MEMORANDUM

SUBJECT: Report for Large Tract Review #2017-01 – 4000 Wisconsin Avenue, NW

SUBJECT: Large Tract Review Case No. 2017-01 – 4000 Wisconsin Avenue NW

Figure 3 – First Floor Plan and Public Space Design (Source: Applicant Plan Set, Sheet A 106, 3/16/17)

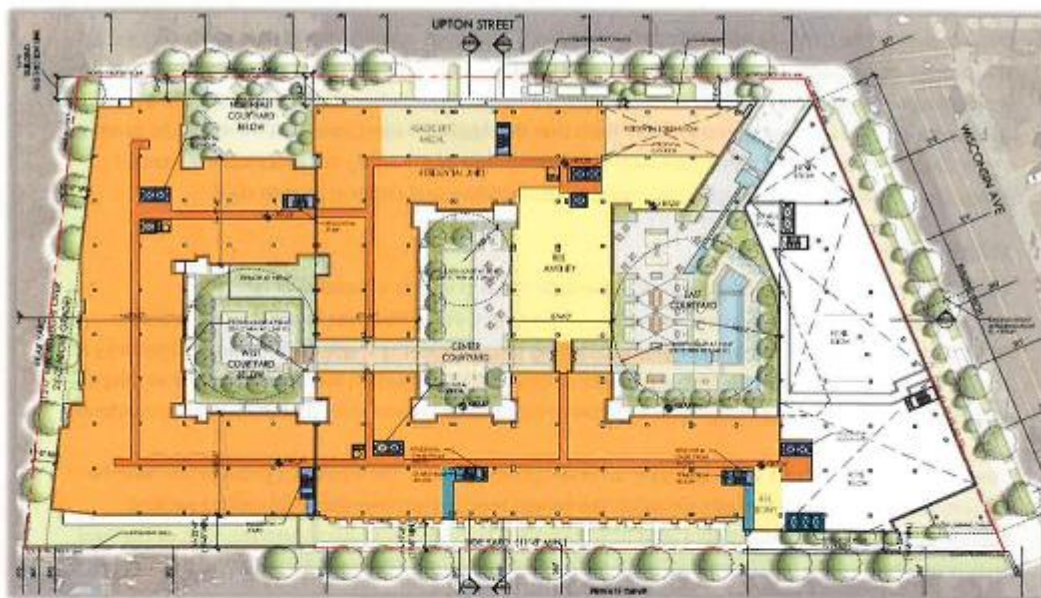
While the preliminary public space plans, shown below in Figure 3, are generally consistent with DDOT standards, there are several considerations that need to be incorporated and items to be reviewed in greater detail during the public space permitting process:

- Public Space Committee (PSC) approval will be required for the three curb cuts on Upton Street NW, two of which are in close proximity;
- The median between the two curb cuts on Upton Street NW should be designed to allow wheel chairs to cross safely;
- Several of the Applicant's drawings (not depicted below) show two additional curb cuts and a circular driveway on Upton Street NW. DDOT assumes these are no longer proposed;
- Bay windows and balconies on Wisconsin Avenue NW may not project more than 4-feet into public space;
- Determine final locations on private or public space for the ZR16 required short-term bicycle spaces; and
- Determine a final location on private or public space immediately adjacent to the site for the 19-dock Capital Bikeshare station proposed by the Applicant.
